Nuclear facilities — Ventilation penetrations for shielded enclosures

AMENDMENT 1

Reference number
ISO 15080:2001/Amd.1:2019(E)

Figure 4

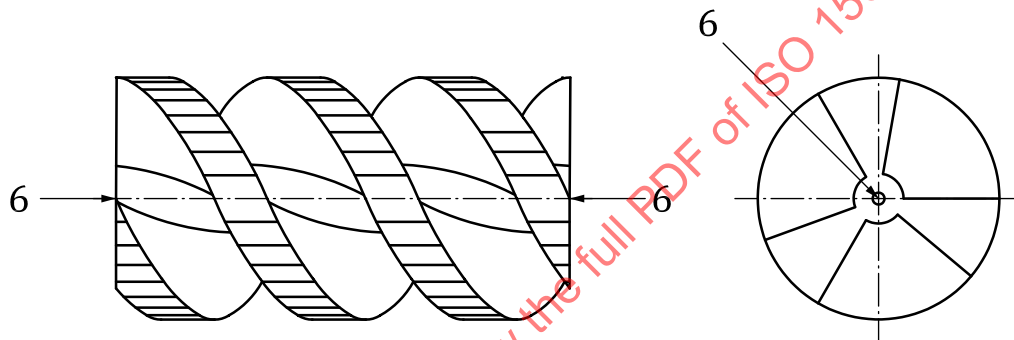
After subtitle a), add the following text:

Subfigure b), replace the figure and the key with the following.

“In order to avoid deposit of aerosol contamination, the handling screw hole should be filled”.

“Key

- 1 pin
- 2 housing
- 3 helix
- 4 flange
- 5 blind nuts
- 6 handling screws”
